Re: Pickin House BEA

Re: Local Case No. 2364 -- Picken House, Variance

Re: Picken House

Staff Report: Case # 2364

PROPOSED CONDITIONS

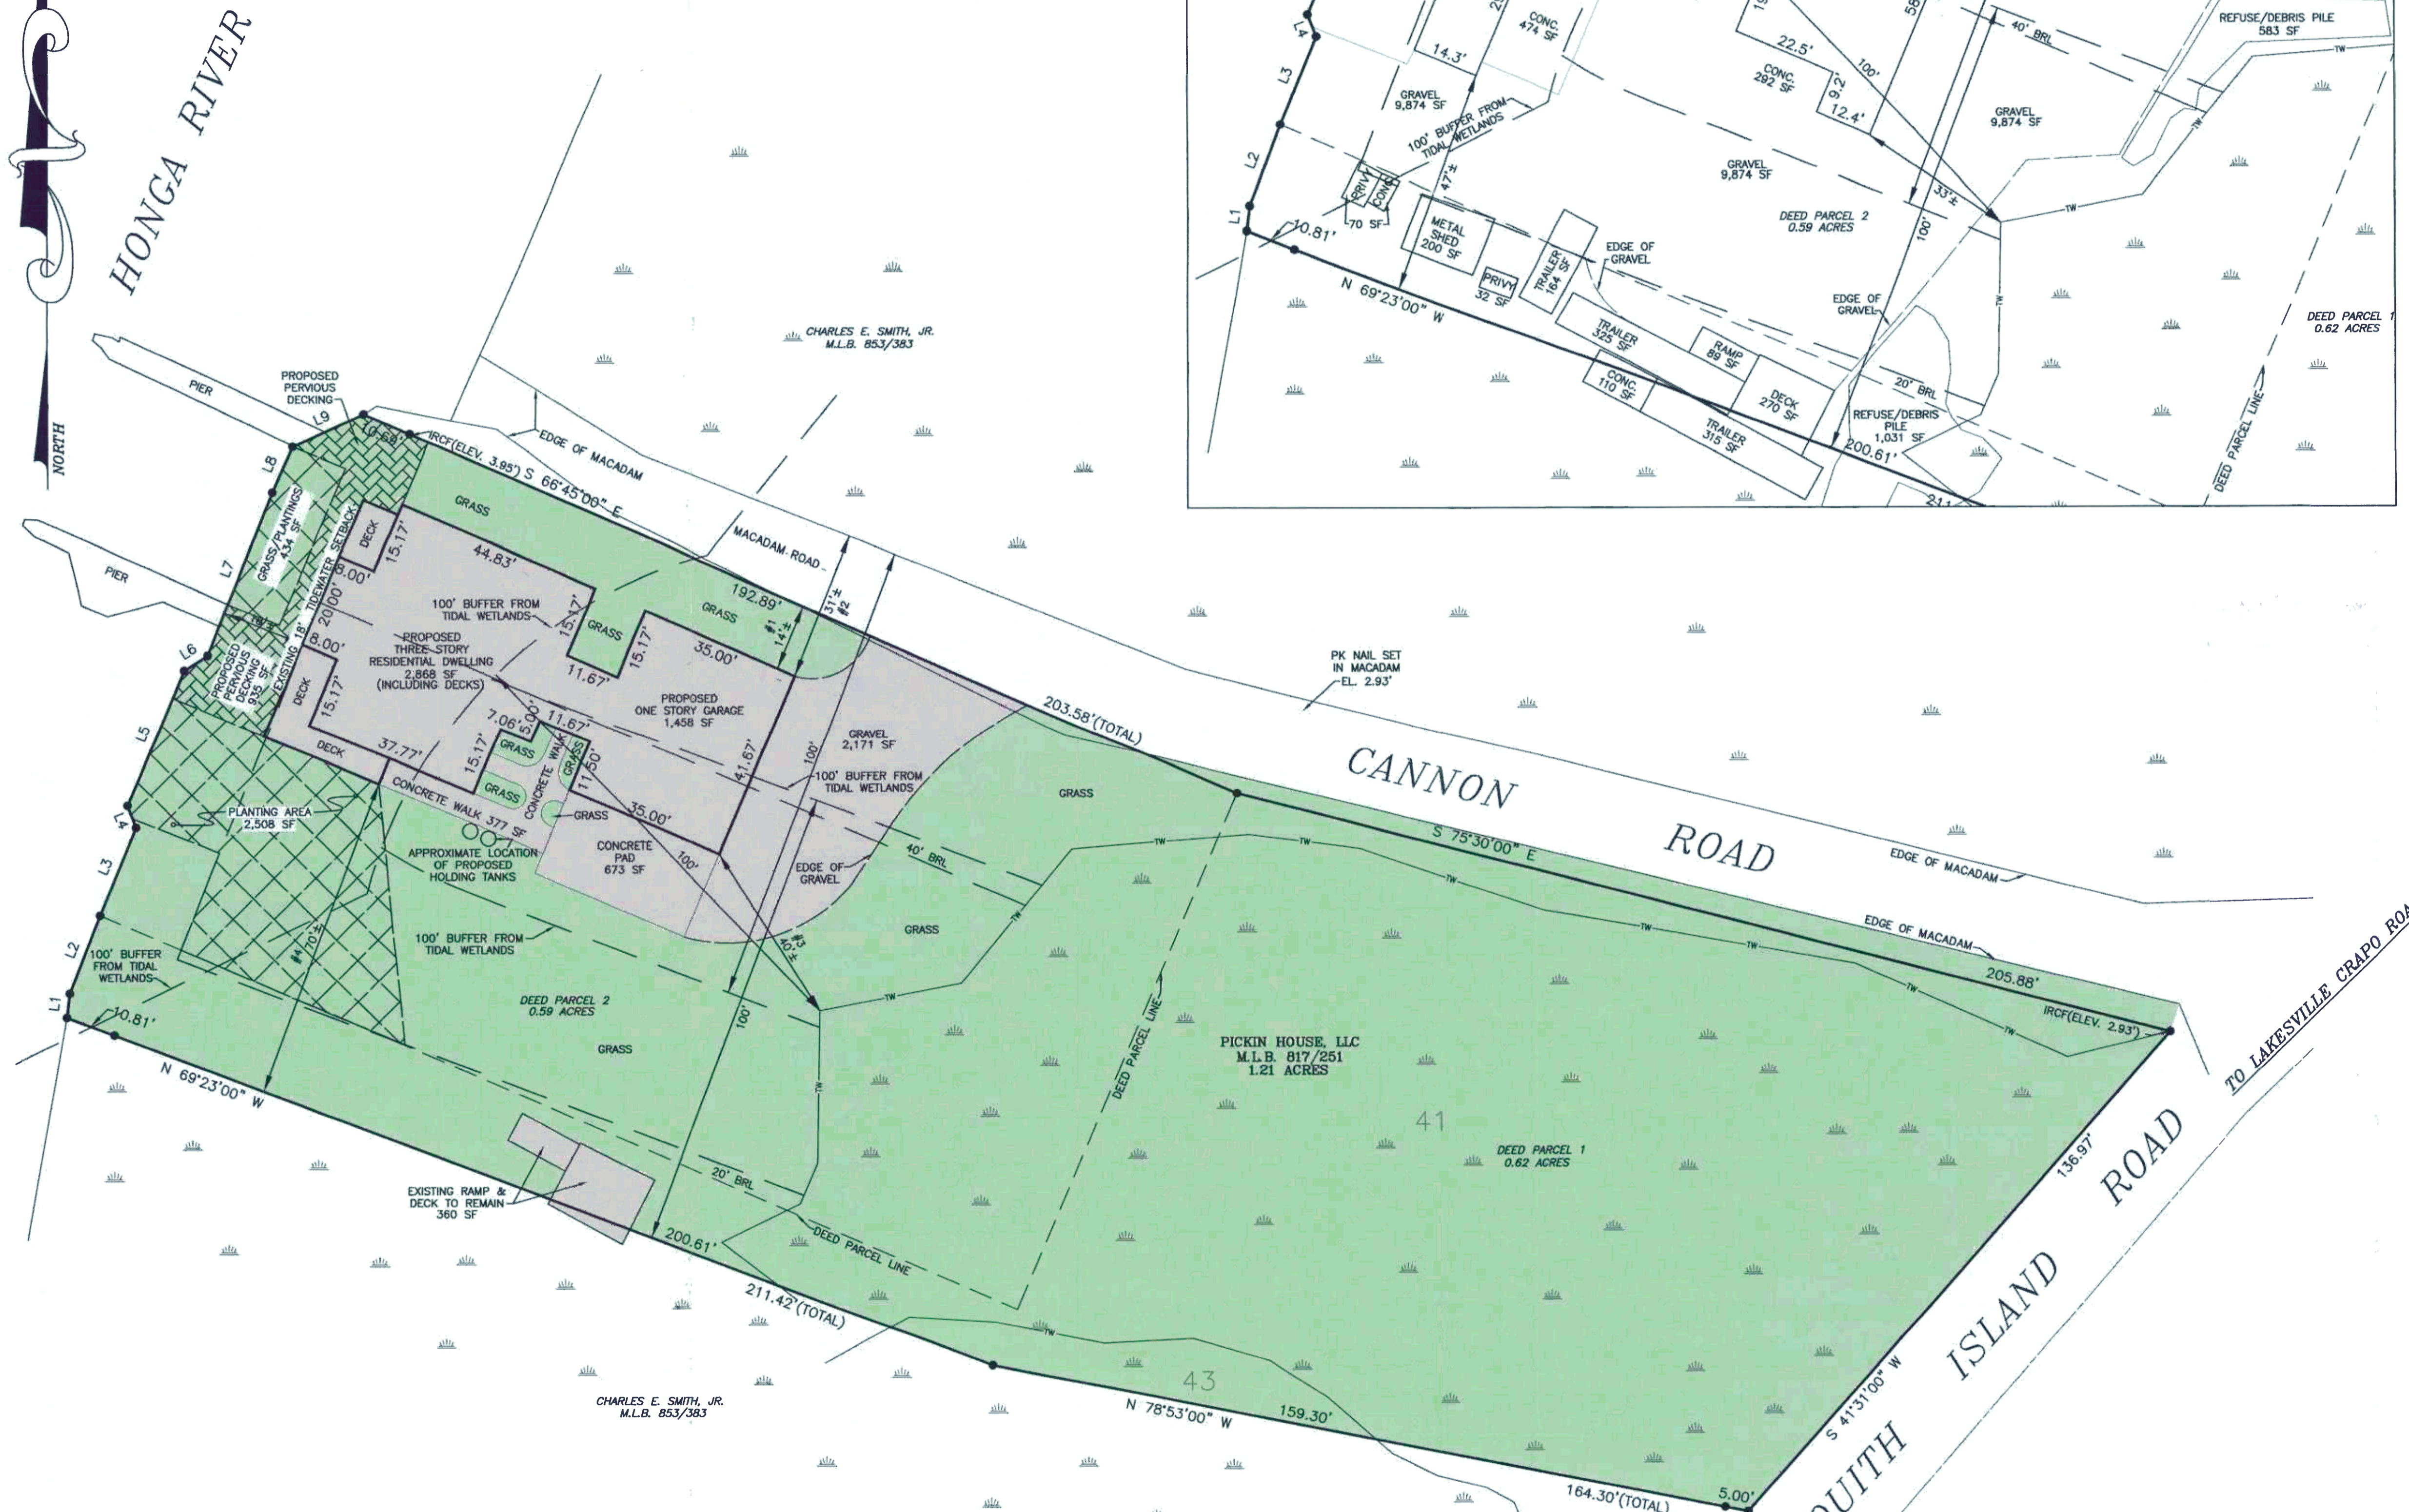
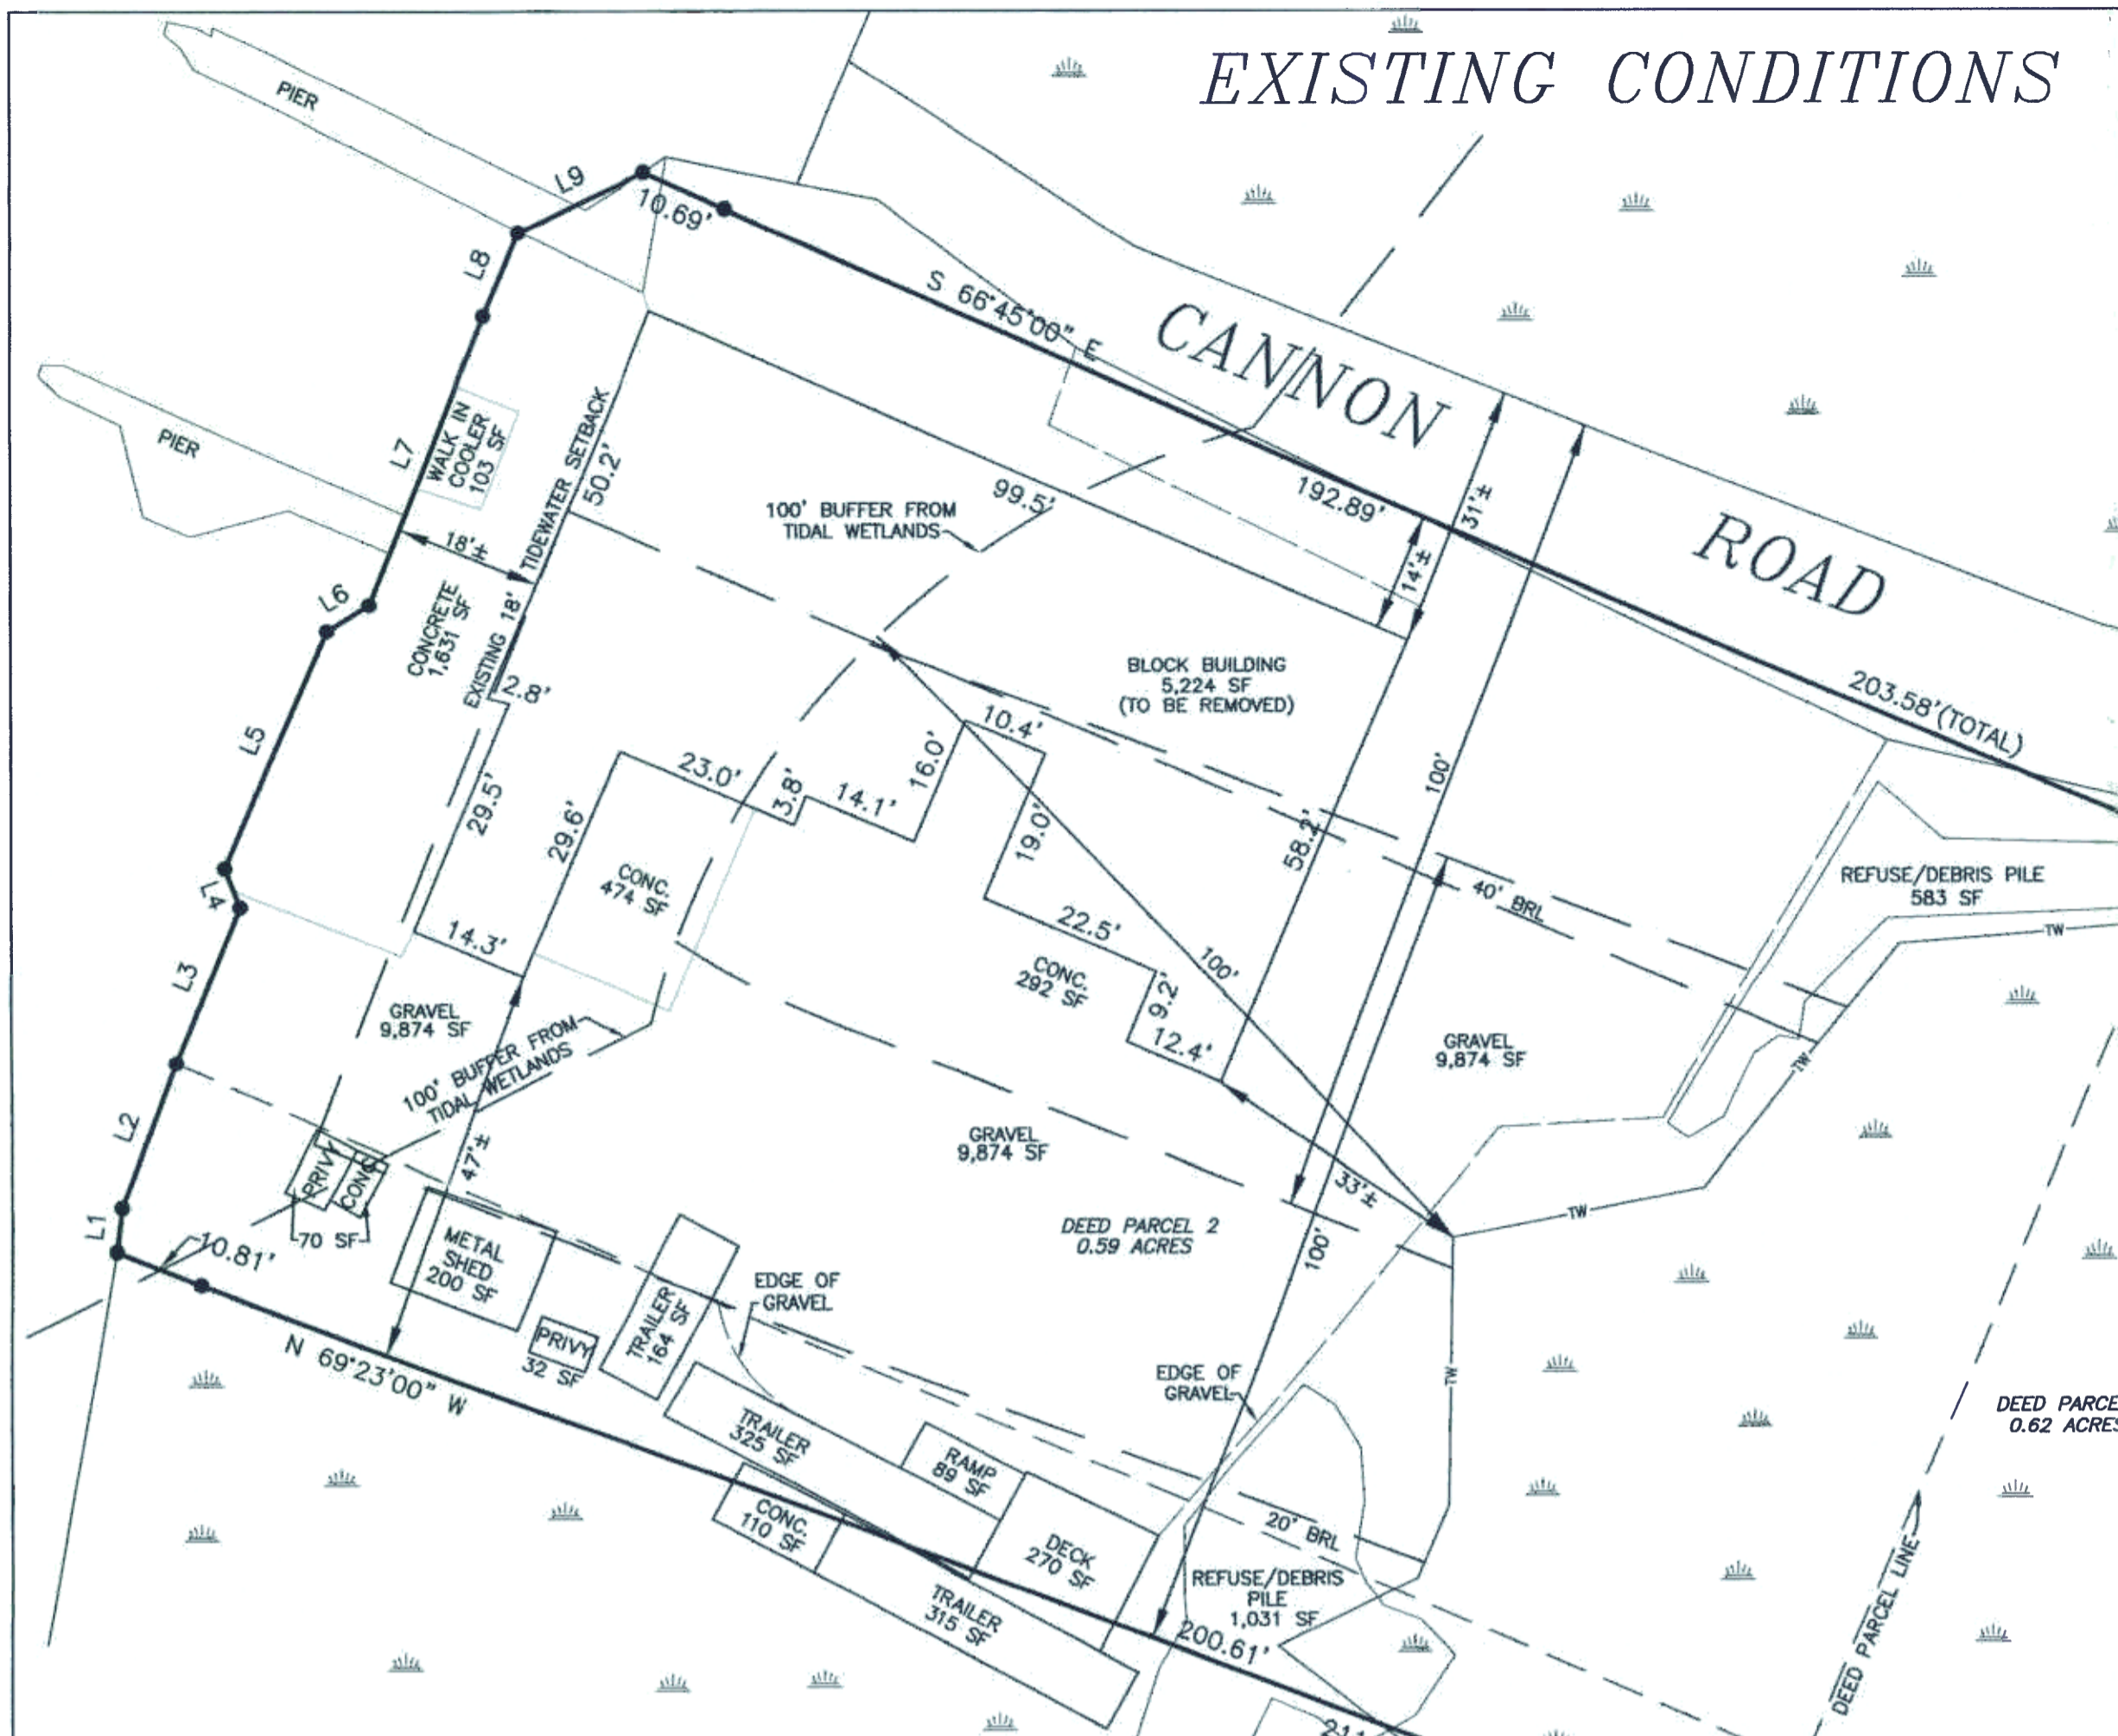
footprint of development, the applicant has not altered the footprint of the residential structure. The applicant has used the primary structure as the setback, although he is proposing close to 1,000 square feet of decking forward of the proposed structure.

It can be demonstrated that there is no feasible alternative but to impact the three Buffers and the BEA in order to redevelop this lot. However, as has been stated previously, given the size of this structure, it is the position of this office that the footprint of this proposed hunting lodge can and should be reduced. Therefore, the proposal does not represent the "least necessary," nor have findings have been provided that indicate that the intrusion is the least necessary. This criterion has not been met.

The residential structure is proposed to be located the same distance from Mean High Water (MHW) of 18 feet as the currently existing crab house. The applicant proposes to replace a concrete slab that extends to the bulk head with the large deck, as was previously indicated. As we have indicated, the applicant proposes extensive redevelopment of this site. It is our position that the proposal be scaled down considerably to satisfy the requirements of the County program.

In addition, Commission staff has repeatedly indicated the importance of plantings on this site, in support of a functional Buffer area. The applicant has shown a planting area of 2,508 square feet to the south side of the dwelling and grass for the remainder of the site area not proposed in deck or gravel (a 434 square foot area between the deck is labeled as "grass/plantings"). In order to meet the 3:1 mitigation ratio for the impacts to the Buffer, the applicant would be responsible for almost 24,000 square feet of mitigation on site, roughly 10 times more than is being offered. Although this office recognizes that this would be very difficult or impossible to place the entirety of these plantings on site, the applicant has not made an acceptable effort to re-establish a functioning Buffer and minimize adverse impacts to water quality.
